Service Letter No. 364A (Supersedes No. 364)

SUBJECT: Detached or Loose Rubatex Blocks in Wing Panels

MODELS AFFECTED: PA-24 and PA-24 "250" Comanches - Serial Nos. 24-1 to 24-2264 inclusive

SERVICE LETTER NO 364 A

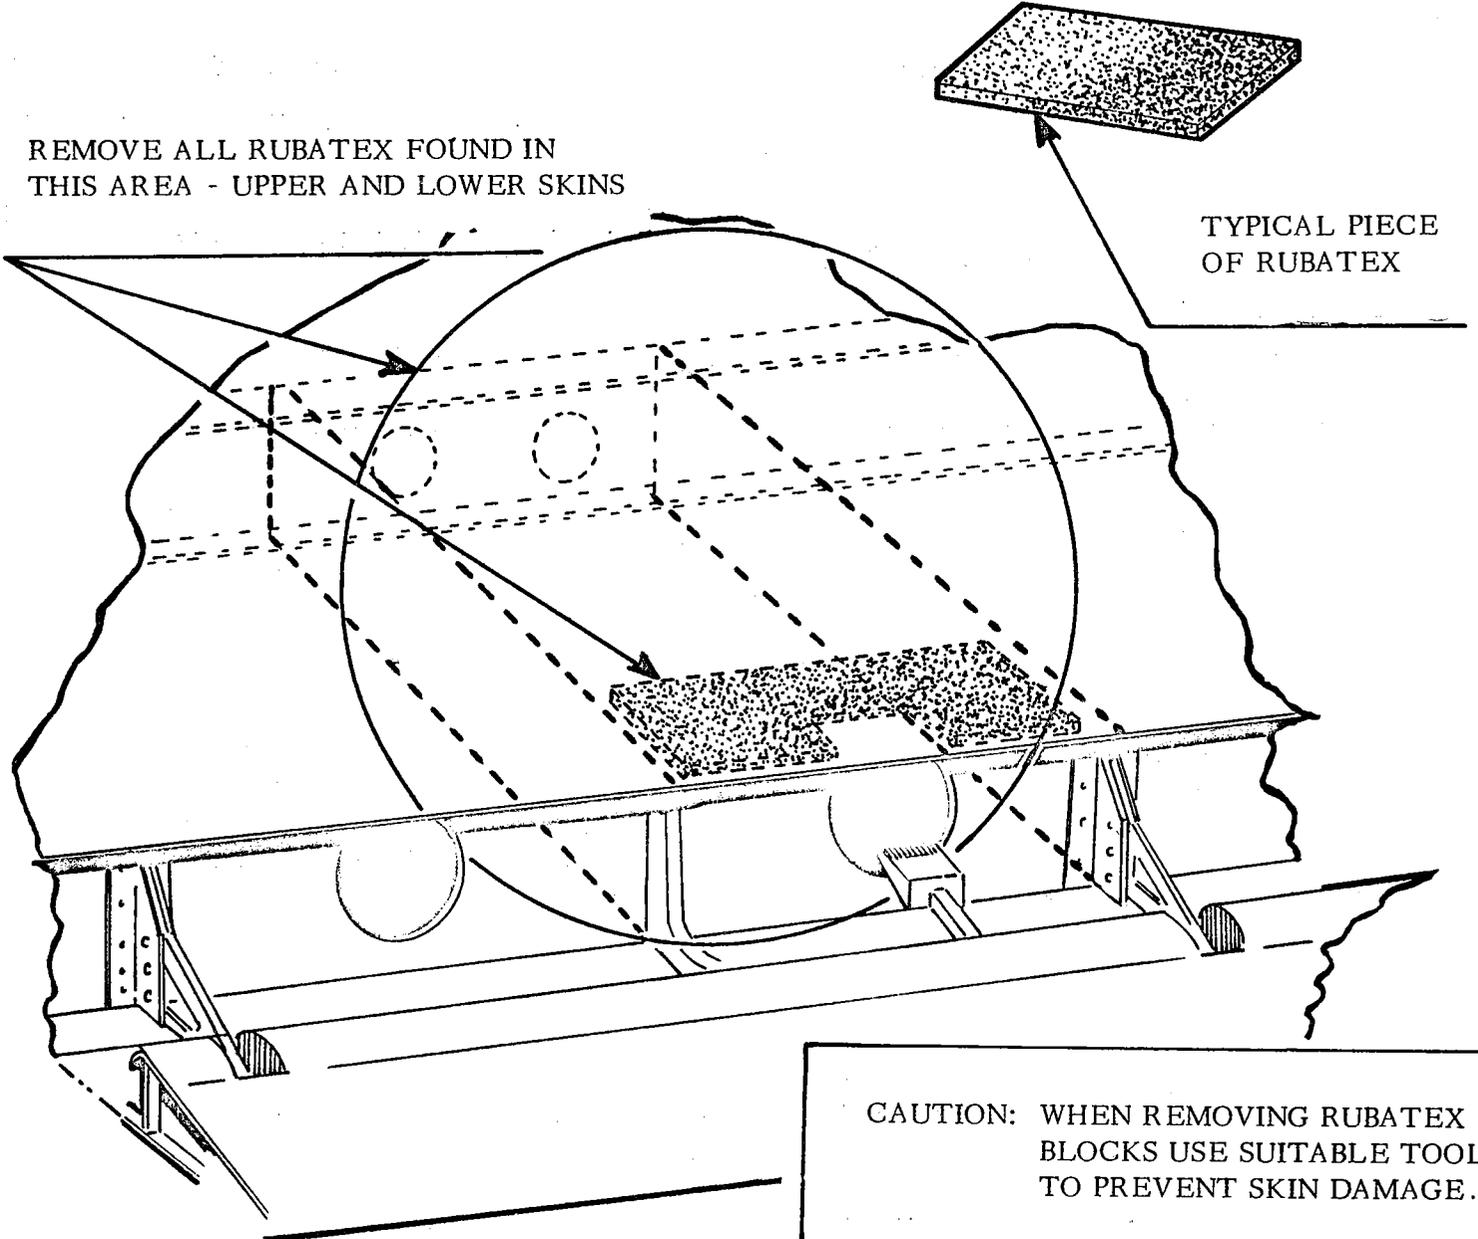
Rubatex blocks were used in a few instances to reduce the tendency of oil canning in the areas of the wing panels, as shown on the sketch on the reverse side of this Service Letter. Prior to but not later than the next 50 hours of operation, this entire area on both wings must be inspected and where these blocks are observed either loose or attached, they are to be removed.

REMOVE ALL RUBATEX FOUND IN
THIS AREA - UPPER AND LOWER SKINS

CAUTION: WHEN REMOVING RUBATEX
BLOCKS USE SUITABLE TOOL
TO PREVENT SKIN DAMAGE.
